TRANS/WP.29/537 30 April 1997

DRAFT SUPPLEMENT 7 TO REGULATION No. 4 (Illumination of rear registration plates)

<u>Note</u>: The text reproduced below was adopted by the Administrative Committee (AC.1) of the amended 1958 Agreement at its fifth session, following the recommendation by the Working Party at its one-hundred-and-eleventh session. It is based on document TRANS/WP.29/R.781, as amended (French only) (TRANS/WP.29/534, paras. 49 and 111).

Figure 1

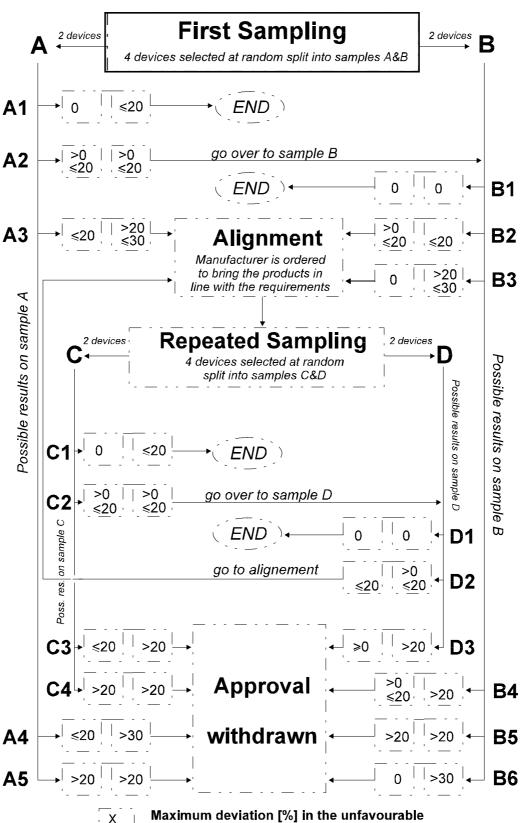
Add new Annexes 6 and 7 to read:

MINIMUM REQUIREMENTS FOR SAMPLING BY AN INSPECTOR

- 2.1. The conformity is not contested
- 2.1.1. Following the sampling procedure shown in Figure 1 of this annex the conformity of mass-produced devices shall not be contested if the deviation of the measured values of the devices in the unfavourable directions are:
- 2.1.1.1. sample A
